Rosefield Solar Farm (EN010158)

**Rosefield Solar Farm – Buckinghamshire Council's Comments
to the Applicant's Updated Deadline 1 Documents**

Buckinghamshire Council

April 2026

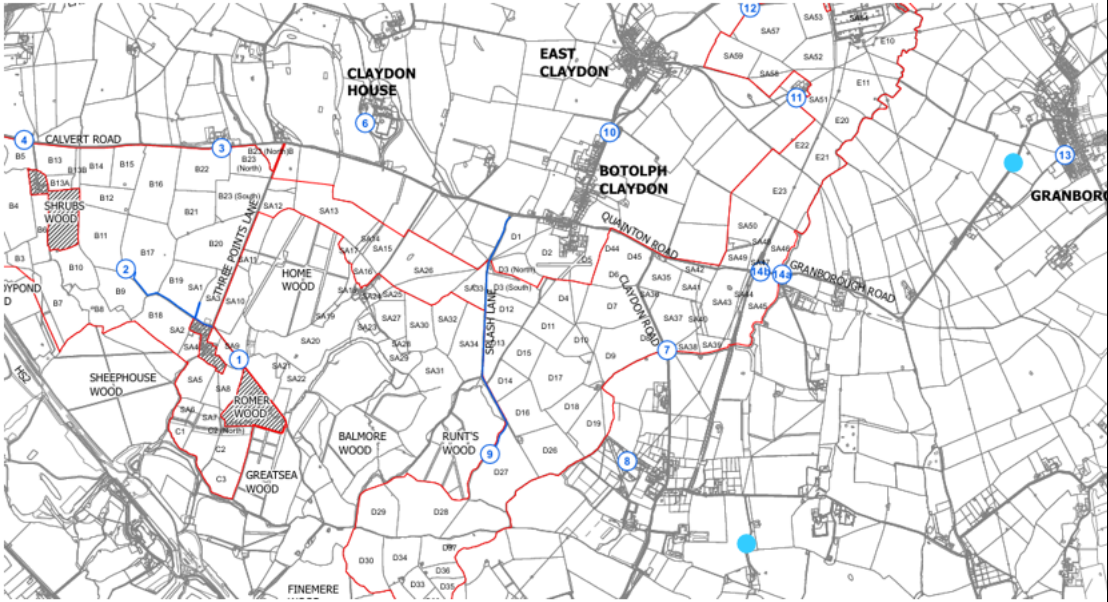
REP1-088	Rosefield Energyfarm Limited	7.7.2 Outline Soil Management Plan (Clean) (Rev 2)	<p>Soils and Agriculture: This document was updated to include this statement “(an experienced person who is trained by a soil specialist) at strategic locations where questions were raised over who would make key soil management decisions”. This is not a secure answer to the Council’s concerns due to its generic nature.</p> <p>Section 5.3.8 is updated to include a clearer statement on how existing land drainage will be managed when disrupted. Section 6.3.7 updated to cover how land drainage will be repaired after trenching. Overall these are minor updates and are not an overall change of position which resolves the Council’s concerns.</p>
REP1-090	Rosefield Energyfarm Limited	7.8.2 Outline Rights of Way & Access Strategy (RoWAS) (Clean) (Rev 2)	<p>Rights of Way: The text amendments which appear in blue are accepted, but, while it’s accepted there is a benefit connecting to SCL/8/1 with the new arrangement, the Council disagrees the revised footpath diversion for the deleted and created network north-west of Pond Farm in Parcel 1 is the best layout possible.</p>

Document Ref and Link	Author	Document Title	Buckinghamshire Council Comments
			<p>The proposed layout is below shown in document 2.4.3 and shown below.</p> <p>Two right-angle bends are created at point SW40 (left and right) which are unnecessary and inconvenient compared to the desire lines suggested in the Council's comments of Nov 2025. If the field is open, walkers will take the direct route anyway. The recommended plan is copied below, where green is created and black is deleted. The Council recommends a revised plan that reflects this proposal. The Council queries why can this not be provided when there are no solar panels in Field B5.</p> <p>It is also uncertain in the plan provided (STREETS, RIGHTS OF WAY AND ACCESS PLANS SHEET 1 OF 8 - EN010158/APP/2.4.3 March 2026) the distinction between pink lines and turquoise lines and which will appear on the definitive map, e.g. there is a pink line SW03 to SW04 passing along the vehicular access to Pond Farm. It is unclear what this represents. The key says, 'Street Works', but it is unclear what this means where this is drawn 1mm beside an existing or a new footpath.</p>

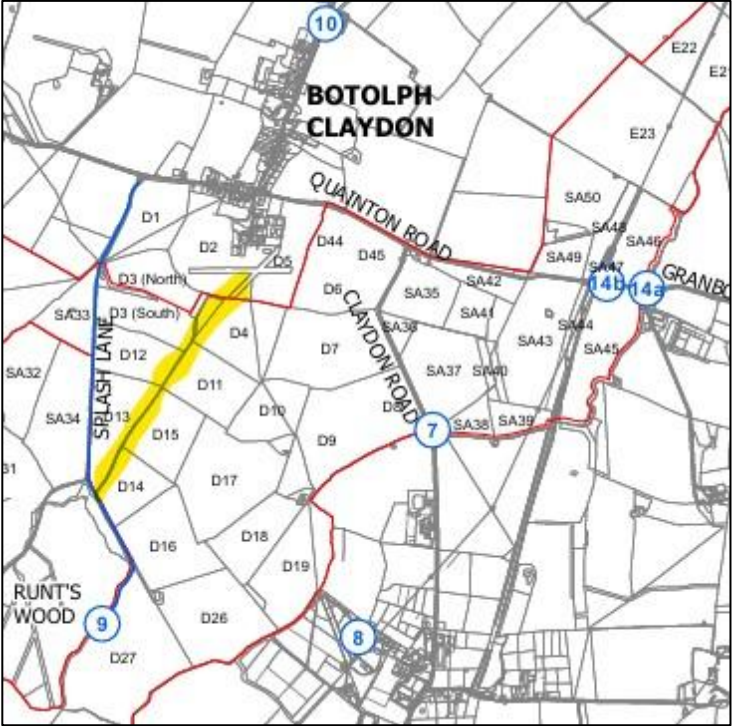
Document Ref and Link	Author	Document Title	Buckinghamshire Council Comments
			<p>b. While further pre-construction evaluation in the form of non-intrusive methods to inform targeted trial trenching is welcome, the Council remains concerned about coverage (being the percentage of land trenched). The Council consider that typically this would need to be 4% of areas of infrastructure or where geophysical survey indicated potential archaeological sites, and 2% otherwise. The Council request these figures are included in the DAMS and that such matters be to be agreed with the Council.</p> <p>Covered by DAMS 4.3.1 & 4.3.3</p> <p>Archaeology and Solar Farms Good Practice Guide. Advice for Developers, Archaeological Advisors, Consultants and Contractors Prepared by Solar Energy UK, Historic England, FAME, CifA, ALGAO UK</p> <p>c. The DAMS para 4.3.10 outlines what will be included in the report for the trial trenching. There should be a section on reporting and publication of the results, which includes that the Council's Historic Environment Record will be supplied with copies of all of the reports which have been approved by Buckinghamshire Council and Historic England in hard and digital format.</p> <p>Covered by DAMS 4.2.7, 5.4.25,</p> <p>d. Where archaeology can be preserved in situ, which is included in the DAMS para 5.1.1 and 5.1.2, the methodologies for this should be demonstrated to be appropriate and agreed with Buckinghamshire Council and Historic England.</p> <p>Covered by DAMS 5.1.1, 5.1.2, 5.5 – 5.5.4</p> <p>e. The DAMS should include a section on public engagement, to include things such as podcasts, updates to the local communities with presentations and field visits and participation in excavations where safe and professional to do so.</p>

Document Ref and Link	Author	Document Title	Buckinghamshire Council Comments
			<p>Covered by DAMS 4.2.3, 4.2.4, 4.3.2, 4.3.4</p> <p>f. Furthermore, the DAMS should include a section on decommissioning to include that the methodologies for this will be agreed with Buckinghamshire Council and Historic England. The presence, significance and vulnerability of heritage assets should be made clear in the OEMP and DEMP.</p> <p>Covered by DAMS 5.5 – 5.5.4</p> <p>At the meeting these issues were discussed, and the consultant found our recommendations for a), c), d), e) and f) to be acceptable and would update the DAMP and other documents to address these points. Issue b) was discussed and they queried the inclusion of actual percentages for the trial trenching. A good practice guide for archaeology and solar farms has been produced by the main stakeholders including the solar industry. Historic England and I agreed that wording which is consistent with this document should be ok. The updated DAMS covers these issues and has been agreed with Historic England and Buckinghamshire Council Archaeological Service.</p>

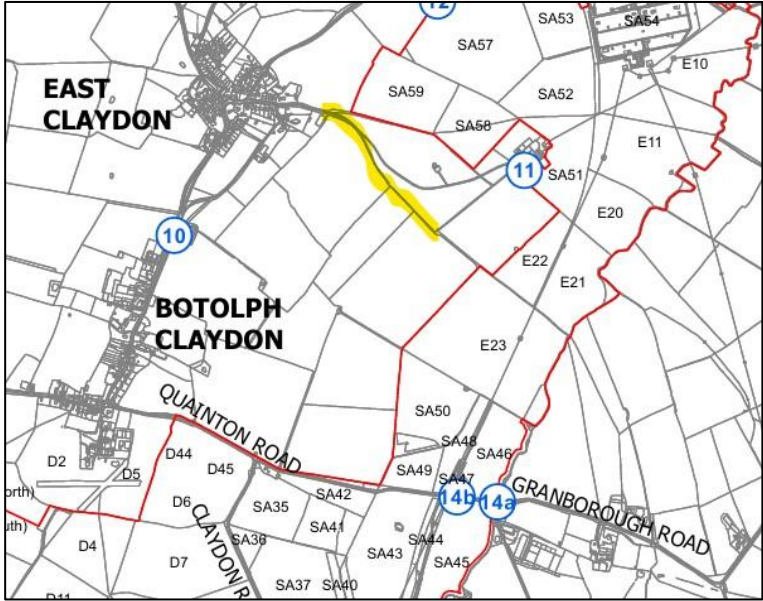
REP1-096	Rosefield Energyfarm Limited	7.11.2 Outline Drainage Strategy (Clean) (Rev 2)	<p>SUDS: Paragraph 2.4.4 has been updated to include an assurance that additional infiltration rate testing will be carried out ahead of detailed design in/around the locations of each proposed pond. Paragraph 11.2.1 has been updated to include reference to further infiltration rate testing as per the above commitment in 2.4.4. The proposed amendments in relation to further infiltration rate testing are satisfactory.</p> <p>Arboriculture: Drainage proposals remain highly relevant where attenuation or drainage features are located close to, or within, woodland or arboricultural buffers. The updated submission appears to indicate that surface water drainage would utilise existing ponds across the site. However, this would still require excavation to create connections between features, as well as the construction of new drainage</p>

Document Ref and Link	Author	Document Title	Buckinghamshire Council Comments
			<p>infrastructure. The key concern remains that buffer strips should operate as development-free exclusion zones and not accommodate excavation, attenuation or other engineered works, particularly where woodland edge integrity is already subject to cumulative pressure. In the absence of a clear buffer strategy, supported by an Outline AMS there is no certainty as to how buffer areas would be protected in practice or how conflicts between drainage infrastructure and arboricultural constraints would be avoided, and the Council's position remains unchanged.</p>
REP1-100	Rosefield Energyfarm Limited	7.14.2 Outline Employment, Skills and Supply Chain Plan (Clean) (Rev 2)	<p>Employment and Skills: The Council welcome the additional text for clarification.</p>
REP1-105	Rosefield Energyfarm Limited	8.5 Bat Technical Study	<p>The applicant has submitted a Bat Technical Study [REP1-105] to provide additional information requested by Natural England. The technical study has attempted to consider whether construction noise or operational noise may impact the bats and also whether the placement of panels within pasture fields grazed by cattle would reduce the foraging resource for bats.</p> <p>The Technical Study has summarized the research relating to the types of invertebrates that <i>Myotis</i> species feed on and how livestock and the type of livestock management has an impact on the invertebrates present for the bats to forage. There is a general consensus within the research that there is a positive correlation between livestock and increased invertebrates available for bats to forage. While the research to date has considered cattle grazing, the relationship with sheep has not been investigated. The technical study has attempted to compare the insect communities associated with sheep and cattle, but has only considered this at a high level; that sheep dung also attracts flies and moths, rather than considering the species assemblages associated with cattle vs sheep.</p> <p>The additional information has not addressed the council's concerns that solar farms may be displacing bats for reasons which are not yet understood. The placement of panels in these fields therefore could make them unsuitable for bats to forage, even if livestock are present.</p>
